**Subject: Response to Comments on 2023 Initial Study Report Meeting Summary,
Rush Creek Project (FERC Project No. 1389)**

Subject: California Department of Fish and Wildlife Comments on Southern California Edison's 2023 Initial Study Report Meeting Summary for the Relicensing of the Rush Creek Hydroelectric Project, FERC Project No. 1389

Figure 1 Hydrology in the Project Area since 2000 (flow over Horsetail Falls)

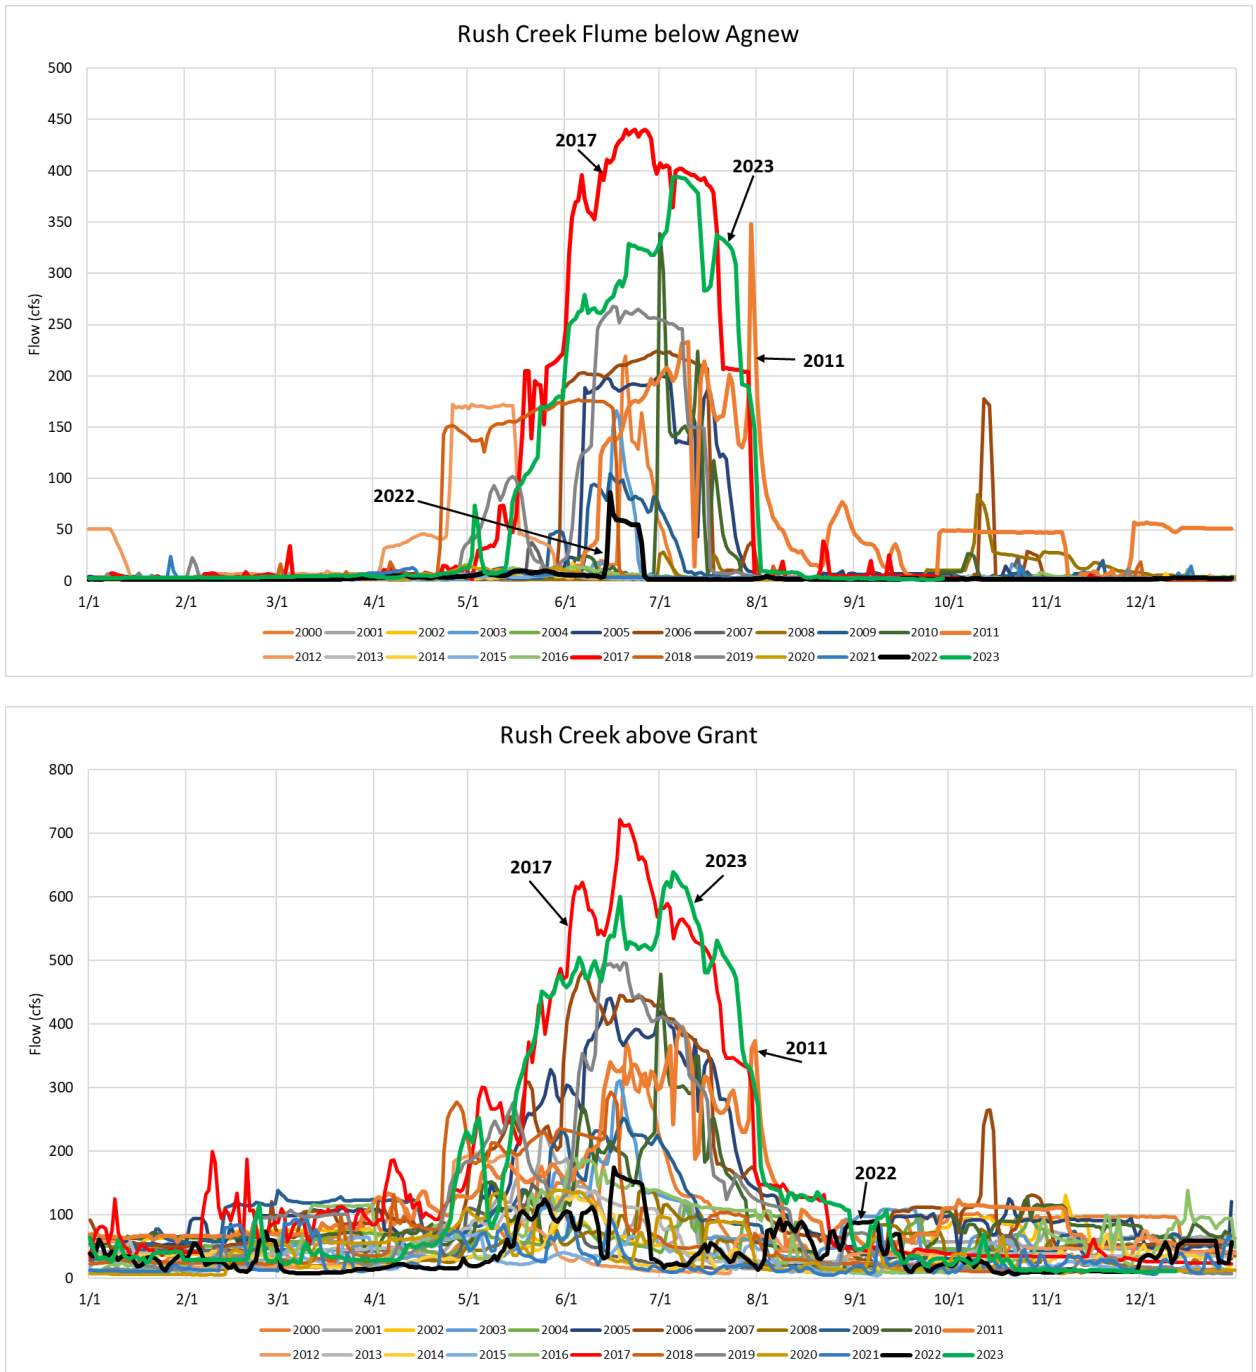
An additional year of data collection should be included for studies AQ-3 and AQ-4 because of anomalous environmental conditions that occurred during water year 2023 (October 1, 2022 through September 30, 2023).

of data collection. CDFW requests this study modification pursuant to the criteria set forth in 18 CFR § 5.15(d)2; the study was conducted under anomalous environmental conditions or that environmental conditions have changed in a material way.

The 2023 hydrology was representative of recent wet years (2011, 2017, 2023) in the Project area (Figure 1). Flows in 2023 in the late summer and fall were representative of other years. Specifically, beginning in August 2023 flows through the Project area were similar to other years, when, after the high snowmelt flows have passed through the system, only storage at the Project reservoirs is released. Thus, FERC’s regulatory standard for justifying a study modification—i.e., that the FERC-approved study was conducted under anomalous environmental conditions or that environmental conditions have changed in a material way (18 C.F.R. § 5.15(d))—has not been met with respect to the State Water Board’s proposed modification.

As described above, the hydrology in 2023 was not an anomalous condition in the Project area, rather it was representative of wet year hydrology with flows returning to lower flows in August 2023. With regard to adult fish sampling, the populations sampled in 2023 were a product of previous years (2020–2023) and representative of adult fish populations in the Project area. Therefore, CDFW’s proposed study modification—with regard to an additional year of surveys of adult populations—is unwarranted under the “anomalous environmental conditions” standard of 18 C.F.R. § 5.15(d). Moreover, the barrier analysis conducted in AQ 6, Fish Population and Barriers Study, was not dependent on flows as the primary barriers were large natural or Project

Figure 1: Annual maximum snow depth recorded at Dana Meadows snow course, 1973 - 2023. California Data Exchange Center station “DAN”, operated by the California Department of Water Resources.

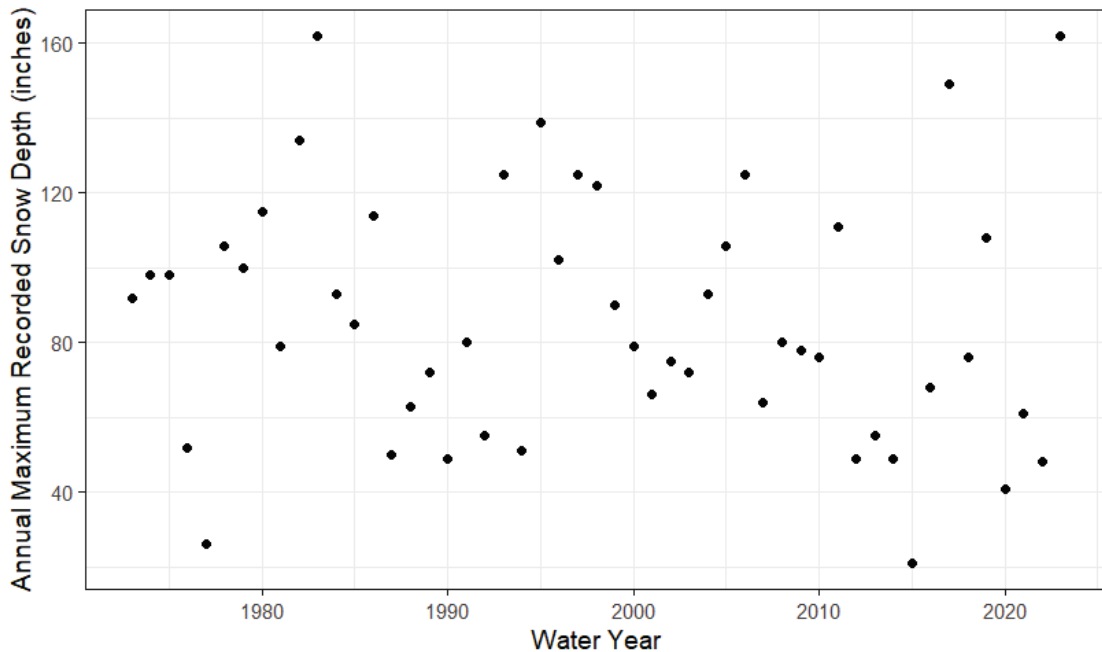
Water year 2023 was an anomalously wet water year throughout the Sierra Nevada, including at the Rush Creek Hydroelectric Project (Project). At the California Department of Water Resources Dana Meadows weather station (Station ID DAN), approximately 12 miles northwest of the Project, the annual maximum snow depth in 2023 was tied (with late March 1983) for the highest on record (Figure 1).

Figure 2: Mean daily flow at West Walker River near Coleville (USGS Gage 10296000), 1939 - 2023.

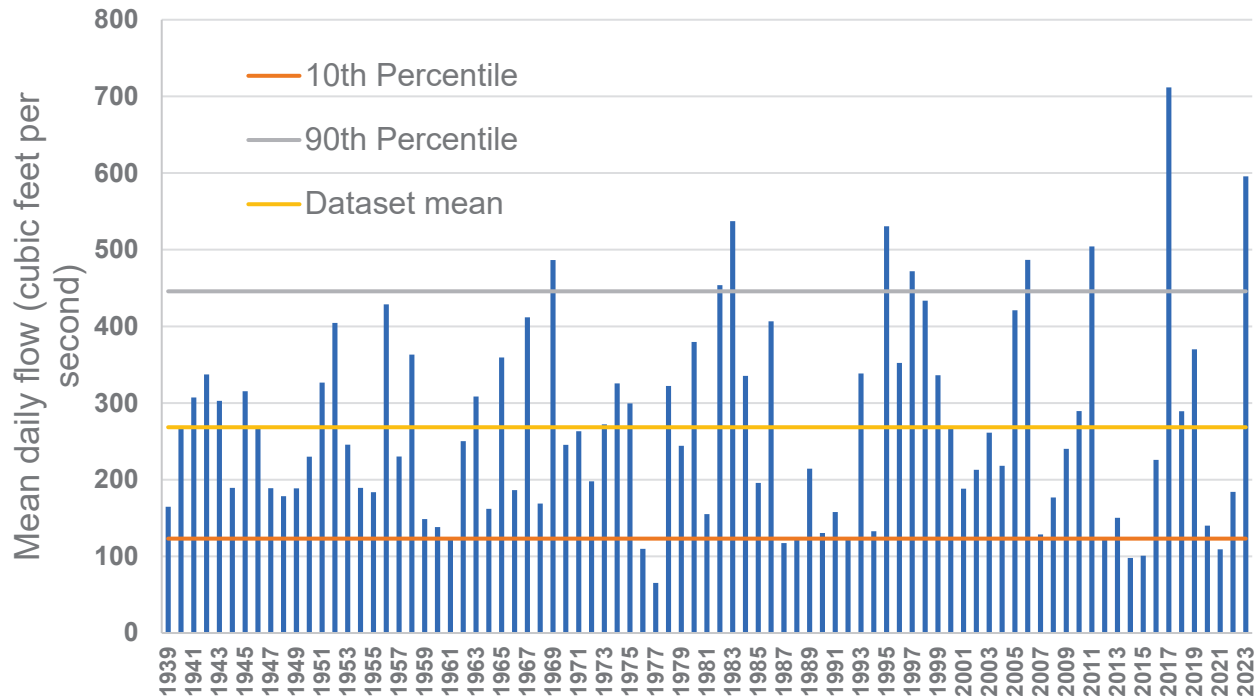
The United States Geologic Survey (USGS) West Walker River near Coleville gage (USGS gage no. 10296000) in the eastern Sierra, which is largely unimpaired by diversions or dams, had the second highest mean daily flow since 1939 (Figure 2).

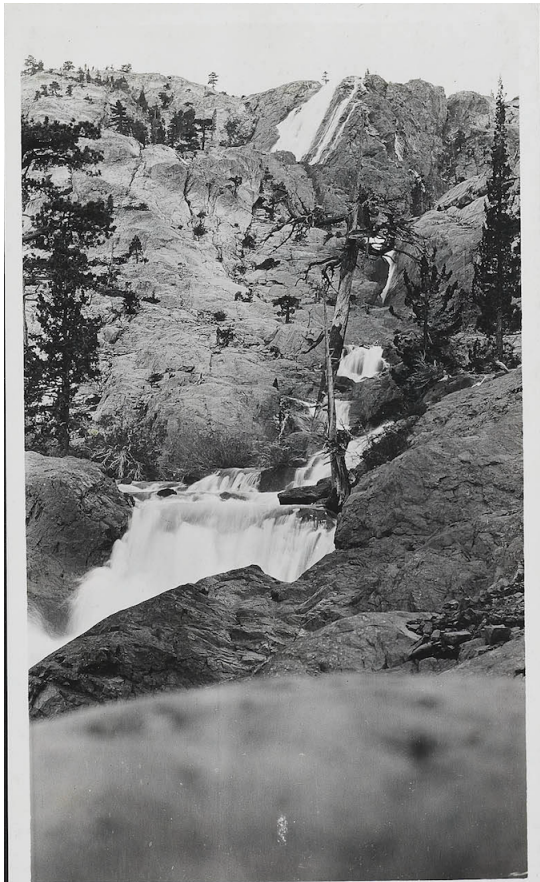
... Establish a key observation point (KOP) on the Rush Creek Trail that, as closely as possible, replicates the point from which the photo below was taken to facilitate comparative analysis and restoration plans.

The pre-dam Agnew Lake level is important to determine for restoring the Rush Creek outlet from Agnew Lake and for regulating restored Agnew Lake levels by estimating the natural Agnew Lake level fluctuations. But equally important is studying the flows into and out of a restored Agnew Lake. Limnological and ecological studies could address the question of how Agnew Lake will change when penstock bypasses are eliminated and greater flows from Gem Lake reservoir are directed to maintain a restored Agnew Lake. How long does the water stay in Agnew Lake? How are water temperature, algae, invertebrates, and fish etc. affected by those changes?

Finally, recently identified photographic resources from 1910-15 make visualizing and rendering the pre-dam Agnew Lake, its basin, and its Rush Creek outlet possible. The 1910 photo below shows that the Agnew Lake basin was more forested than it now is, corroborating evidence cited in HAER (p. 11) that “trees standing on the reservoir site were cut down, sawed into lumber...and erected on the ground by contractors, and used for the forms” for the concrete dam. These newly identified photos also could provide evidence for the TERR-1 study group to analyze and develop vegetation restoration plans. In this photo, the Rush Creek outlet at the far end can be seen flowing through rocks and a forested stand on the way to the site where Agnew Dam was ultimately built. LAND-1 Aesthetics should establish a KOP on the Rush Creek Trail that as closely as possibly replicates the point from which this photo was taken to facilitate comparative analysis and restoration plans.

SCE appreciates the information from Mr. Marks regarding Agnew Lake and Rush Creek immediately below the dam to Horsetail Falls. This information has been provided to SCE's resource experts to utilize during development of the relicensing application for the Project. SCE's proposed study plans (specifically AQ 1, AQ 2, AQ 5, and TERR 1) are sufficient to fully understand environmental conditions and develop PM&E measures, as may be appropriate, in Agnew Lake and the stream reach below the dam. The studies will provide an understanding of the existing environmental conditions and be used to identify potential environmental effects of full and partial dam removal upstream and downstream of Agnew Dam. AQ 1 will provide information on instream habitat, including the reach below Agnew Lake, under a range of flows (including historical flows, existing flows, Proposed Project flows, and unimpaired flows). Similarly, AQ 2 will develop hydrology characterizing historical flows, existing flows, proposed Project flows, and unimpaired flows. AQ 5 will characterize erosion, stream bank stability, and sediment deposition in Rush Creek, including below Agnew Lake. FERC's Study Plan Determination requires SCE to characterize sediment deposition and test for containments in sediment in the Project reservoirs (Waugh, Gem, and Agnew Lakes). Finally, TERR 1 characterizes botanical resources including riparian resources in Rush Creek below Agnew Dam. With regard to the photo of Agnew Lake provided, a KOP from this relative location was already established during the 2023 field season as part of the LAND 1 Aesthetics Study.
